**Reference No:** 21/02709/PP

**Proposal:** Variation of condition numbers 3, 4, 5 and 6 and removal of conditions 7 and 8 relative to planning permission 20/01150/PP (Erection of dwellinghouse). Access arrangements

**Site Address:** Rhu Lodge, Ferry Road, Rhu, Helensburgh, Argyll and Bute, G84 8NF

**SUPPLEMENTARY REPORT NO. 1**

This supplementary report has been provided with regards to proposed drawing reference 19/20/10 as an updated drawing (ref: 19/20/10 REV A) below, has been supplied by the applicant. The roads officer has provided further comment on this drawing and has noted;

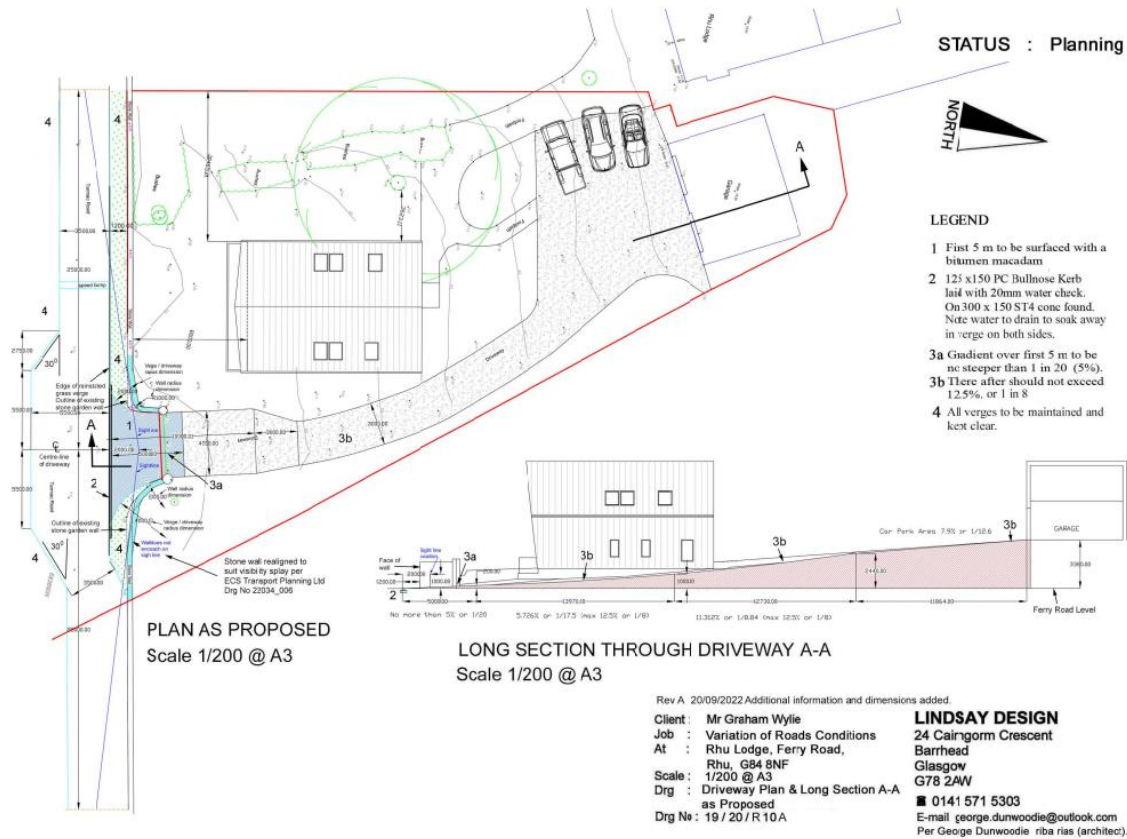
*Whilst the details as shown within this drawing noting the 4.5m wide driveway for the first 10m, the radius and the kerb with water check are correct, it is noted that they have been shown in the incorrect location as these should be measured back from the boundary wall and not from a point beyond the boundary wall therefore, the details contained within this drawing are not acceptable.*

In terms of the proposed passing place at the driveway access and proposals to install a grass verge, it is noted that the visibility splays as detailed within revised drawing 9/20/10 REV A show the splays taken from a point beyond the boundary / edge of existing carriageway. There is no existing verge, if the applicant wishes to realign the road to install a verge then we would need specific details on this, in terms of road construction. Furthermore, this would no longer solely be assessed as a passing place but as a road realignment and therefore, the details within this drawing are not acceptable as the angle is too acute hence the requirement for a condition.
